Re: Requests for Additional Information - 191 O'Riordan Street, Mascot NSW – DA 14/095

DA 14/095 (Commercial Building and Hotel Building DA)

Re: Commercial and Hotel, 191-203 O'Riordan Street, Mascot Response to Council regarding parking provision and arrangement

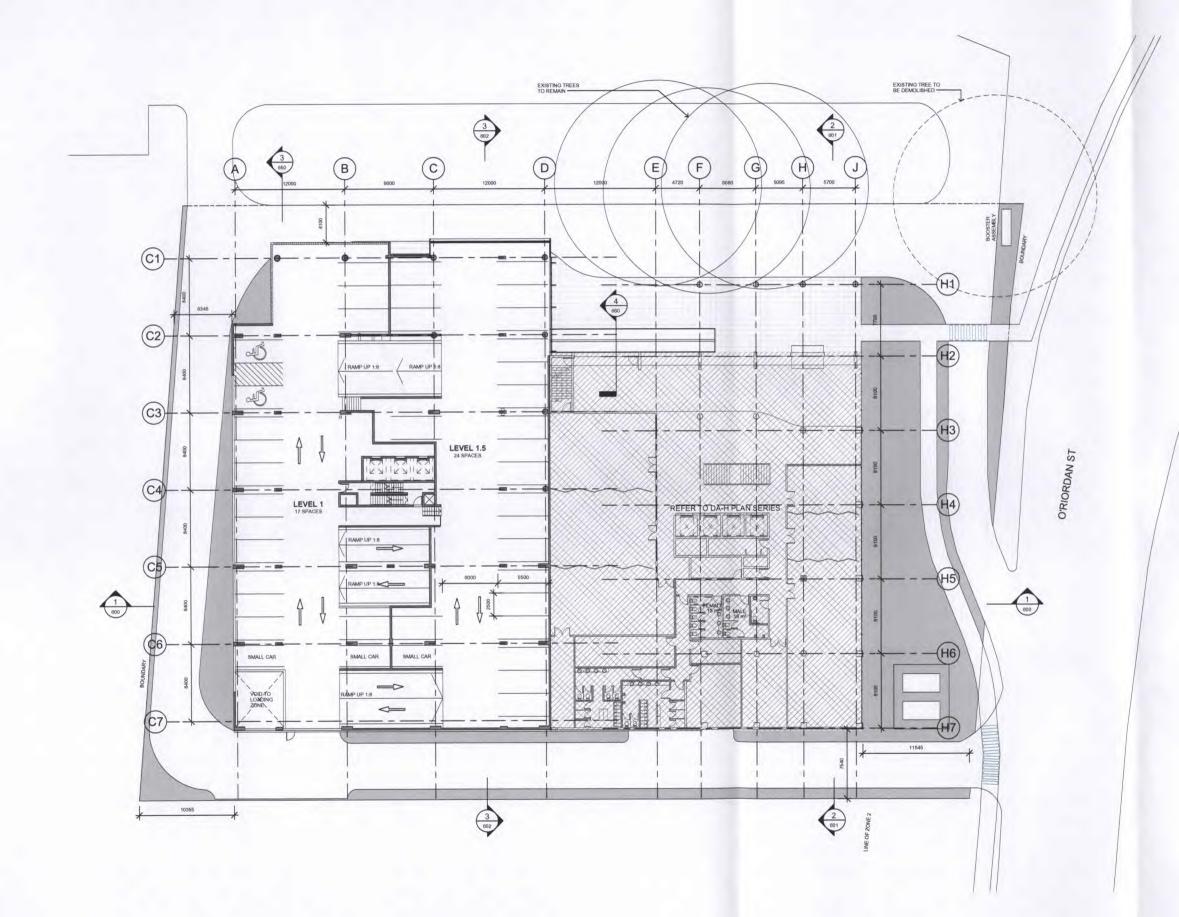
- The comms room has been relocated and the sprinkler/pump room narrowed to provide 1 additional space;
- +4 spaces at Level 1.0:
- At the northeast corner of the car park, the wall separating Level 1 from Level 1.5 has been moved to the east providing an area for 2 additional spaces (this area previously provided one parallel parking space);

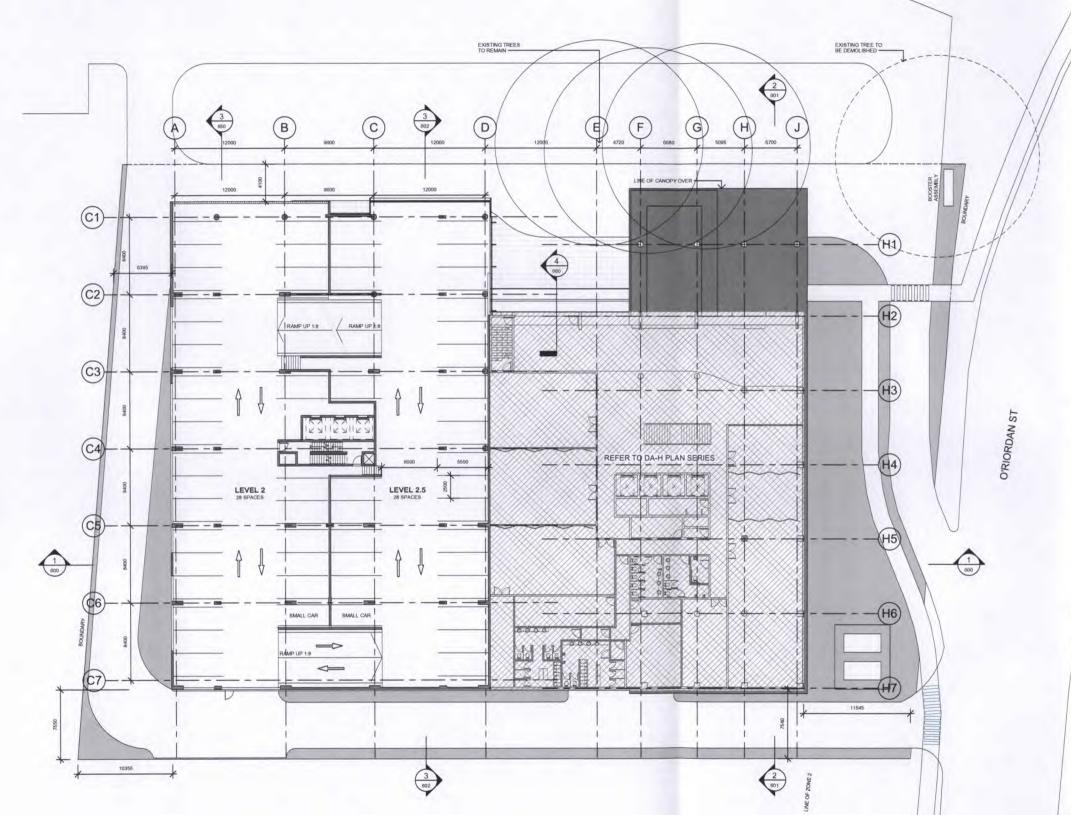
- Noting that all hotel guests will (including disabled users) have their car parked by the valet service, the two 2.4 metre wide 'shared areas' on Level 2 associated with the four hotel disabled parking spaces, have been converted to provide 2 additional parking spaces;

Drawing No. DA-C100		C
1:200@ A	1	Drawing Star A1
Propert No 1322	MAR 14	JH/DMcD

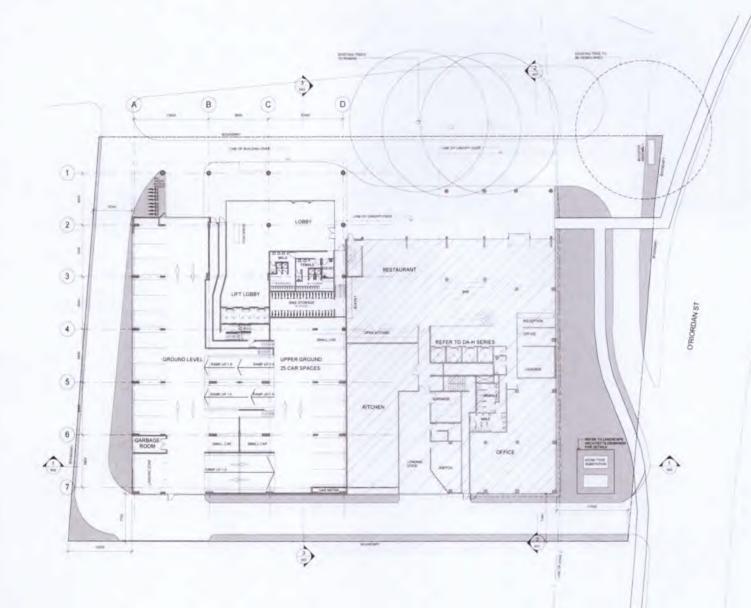
DA-C100 Issue C dated 01.08.2014

Sydney Water has no objection to proceed with the development as per the above drawing subject to the following conditions, which need to be addressed prior to stamping the plans by Sydney Water for construction:

- Proponent is required to identify the exact location of the stormwater channel prior to commencement of work at the site and need to ensure all proposed structures are 1m away from the actual location of the stormwater channel. Depend on the actual location of the channel some changes may require. For the construction purpose, location of the easement position cannot be considered as location of the actual position of the channel.
- Details of the access arrangement across the stormwater channel is to be provided. Proponent should ensure that the access arrangement across the stormwater channel should not impede the overland flow through the site.
